**ADDENDUM 1                      November 9, 2016**

RE:                      UTHSC  
                             Switchgear Replacement

FROM:                 Shah Smith and Associates, Inc.  
                             2825 Wilcrest Dr., Ste. 350  
                             Houston, TX 77042

This Addendum forms a part of the Contract Documents and modifies the original Construction Documents dated September 30, 2016 as noted below:

PWP Project Number	215-218R
Date	11/09/2016
Designed By	DS
Checked By	BL
Drawing No.	<b>A-101</b>
Scale	As indicated

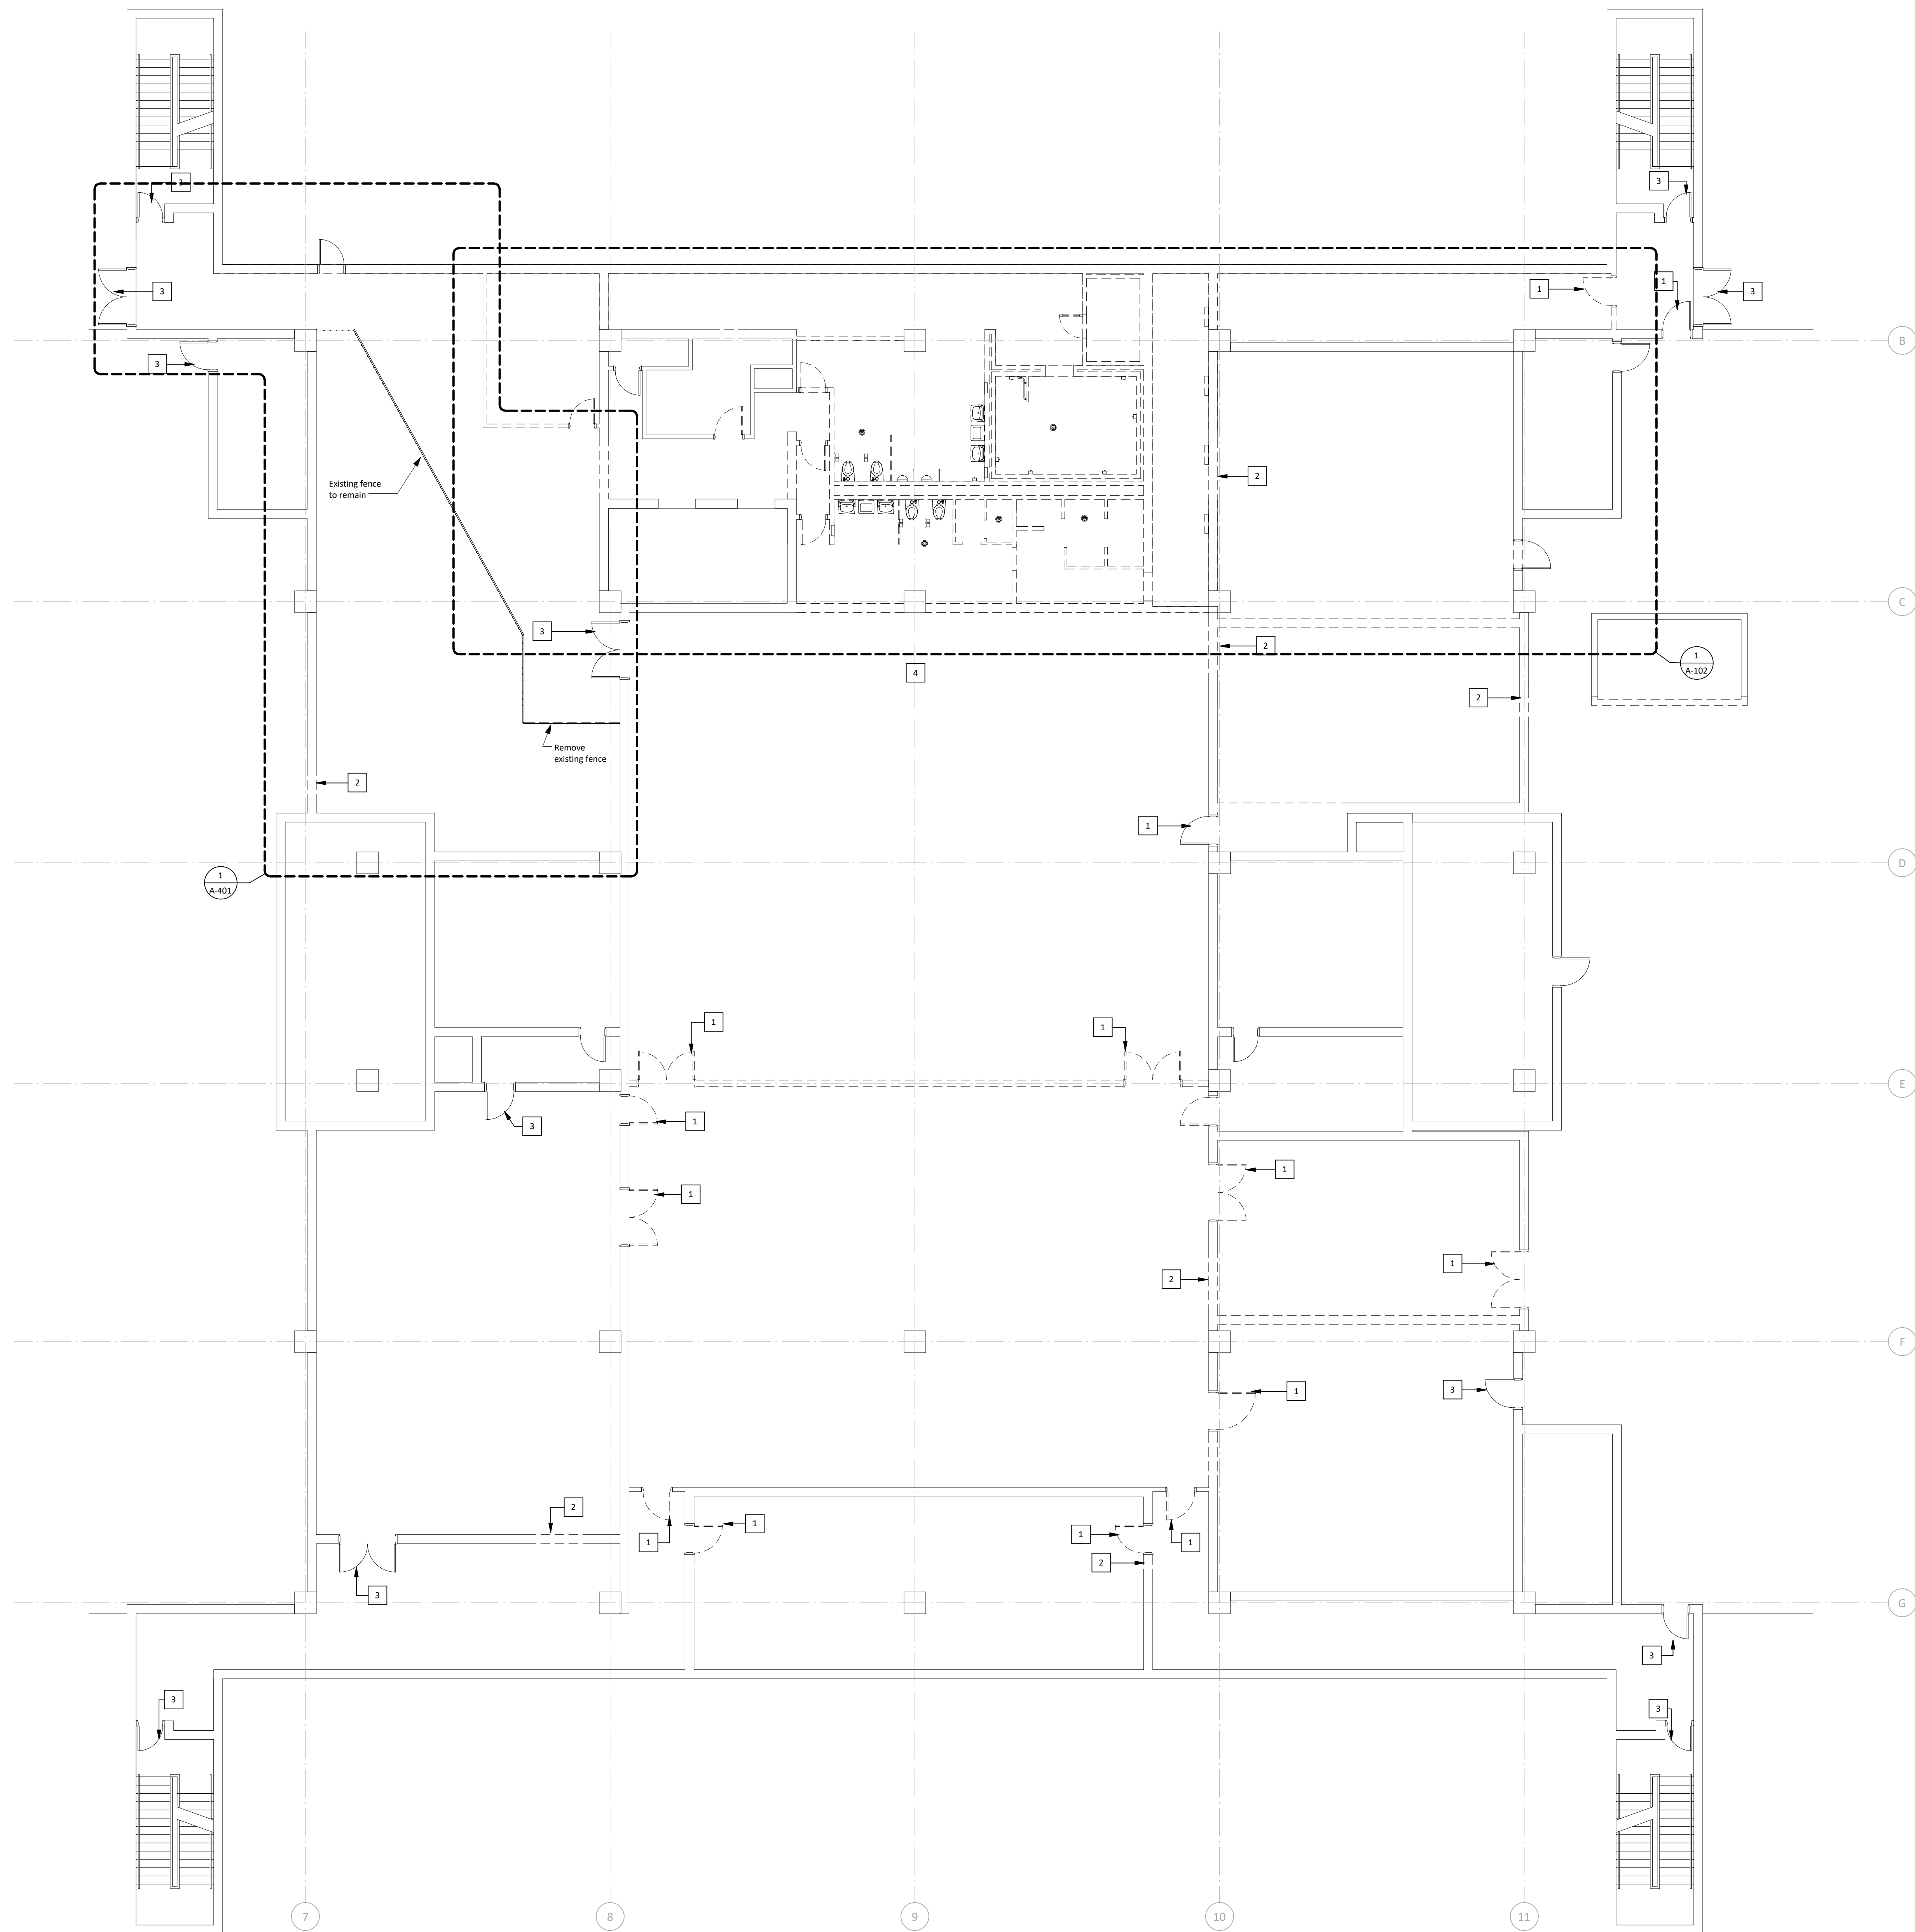
1. Sheet A-101 – Added Floor Note
2. Sheet A-111 – Updated Detail
3. Sheet A-400 – Added Notes
4. Sheet A-401 – Added Floor Note
5. Sheet A-540 – Updated door sizes.
6. Sheet E016 - Updated wiring requirements.
